# Access Compliance Report

## Public Rights-of-Way

### (Curb Ramps)

Intersection ID: 16439	Main Street: SOUTH_BV	Cross Street: SCALEYBARK_RD	Location: NW
ADA ID: 3BEF5BCDE5D1	Ramp Type: Para	Initial Pass/Fail: Fail	Overall Compliance: No
Severity Score: 13.75			
Codes/Mitigation Info/Possible Solution		Field Measurements/Component Compliance

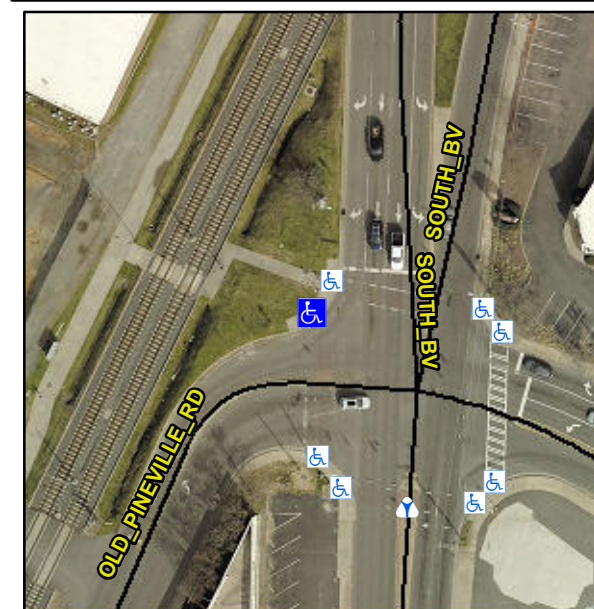
**R304.5.3, R304.3.2**

Compliance	Description	Data	Compliance	Description	Data
N/A	Ramp Length LT (in)	58.0	N/A	Ramp Length RT (in)	62.0
Yes	Ramp Width LT (in)	72.0	Yes	Ramp Width RT (in)	72.0
Yes	Ramp Slope LT (%)	5.8	No	Ramp Slope RT (%)	10.6
No	Ramp XSlope LT (%)	2.3	No	Ramp XSlope RT (%)	2.7
N/A	Landing Length (in)	N/A	N/A	DWS Provided?	N/A
N/A	Landing Width (in)	N/A	N/A	DWS Contrast?	N/A
N/A	Landing Slope (%)	N/A	N/A	DWS Length (in)	N/A
N/A	Landing X Slope (%)	N/A	N/A	DWS Full Width?	N/A
N/A	Landing Curb? (Y/N)	N/A	N/A	DWS Offset (in)	N/A
N/A	Shared Landing?	N/A			
N/A	Gutter Ponding?	N/A	N/A	Gutter Slope (%)	N/A
N/A	Gutter Lip Ht (in)	N/A	N/A	Gutter X Slope (%)	N/A
N/A	Painted X Walk1?	Yes	N/A	Painted X Walk2?	N/A
	X Walk 1 Direction	To S		X Walk 2 Direction	N/A
N/A	X Walk 1 Width (in)	122.0	N/A	X Walk 2 Width (in)	N/A
	X Walk 1 Slope (%)	1.4		X Walk 2 Slope (%)	N/A
	X Walk 1 X Slope (%)	1.7		X Walk 2 X Slope (%)	N/A
N/A	Ramp inside XWalk1?	Yes	N/A	Ramp inside XWalk2?	N/A

**Remove & Replace Entire Ramp.**
